RE: **Lot 10 Block 2 Unit 22**
Volcano Cliffs SAD 228
6327 Canavio Rd. NW
Grading and Drainage Plan
Engineers Stamp Date 5/12/2020 (D10D003C10)
Pad Certification Date: 9/23/2020

Based upon the information provided in your submittal received 9/25/2020, this plan is approved for Building Permit.

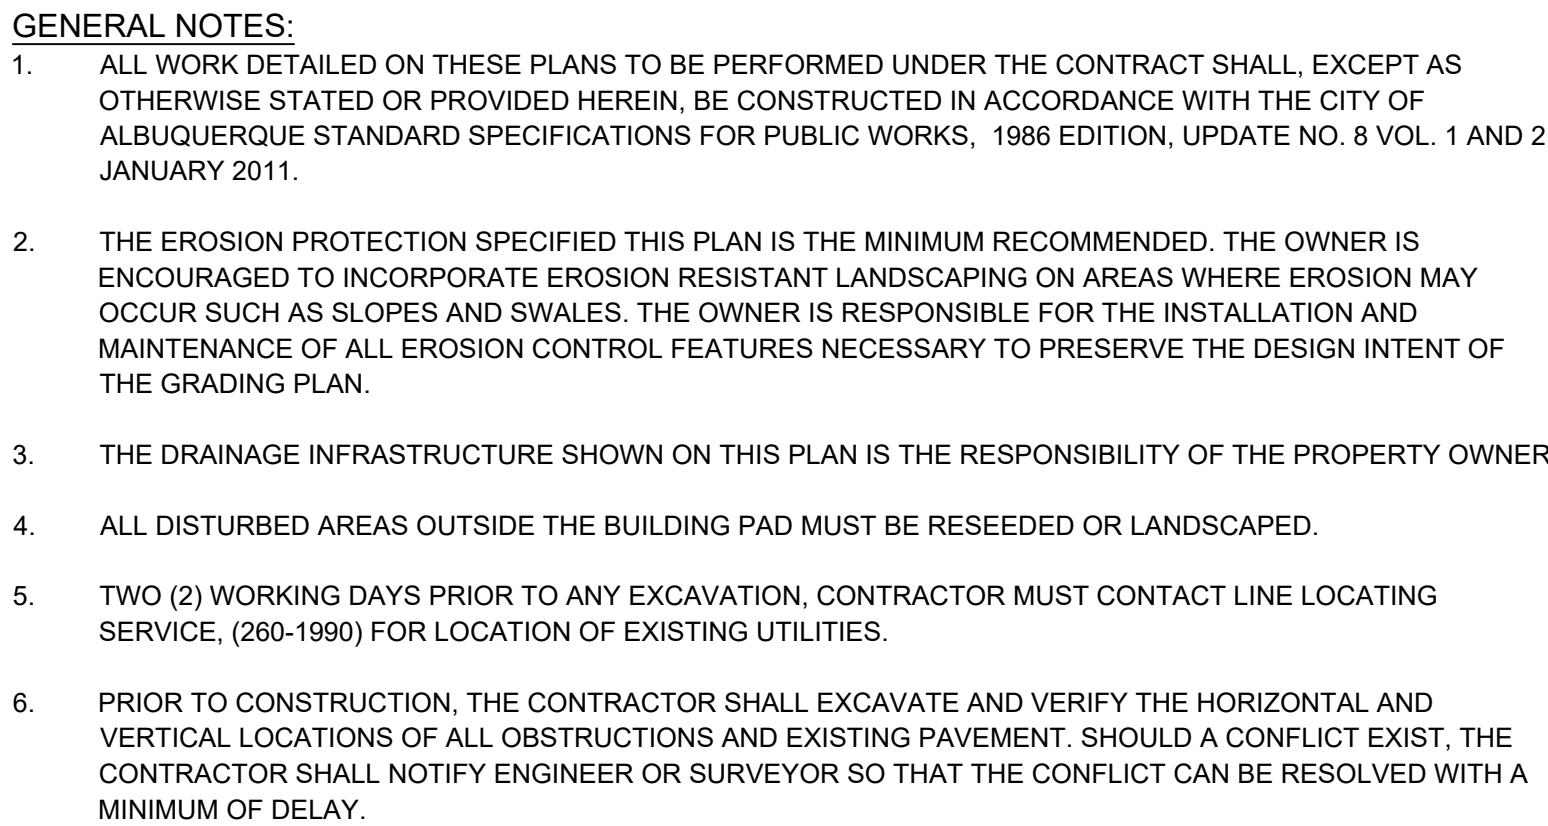
Prior to Building permit approval a Pad Certification will be required, provided by the Engineer or a registered Land Surveyor.

Reiterate to the Owner/Contractor that a separate permit for a garden/retaining wall must be obtained with the approved G&D plan and Pad Certification. **Also, if a swimming pool is to be added after this approval the grading and drainage plan will change and will need to be resubmitted.**

Prior to Certificate of Occupancy release, Engineer Certification per the DPM checklist will be required.
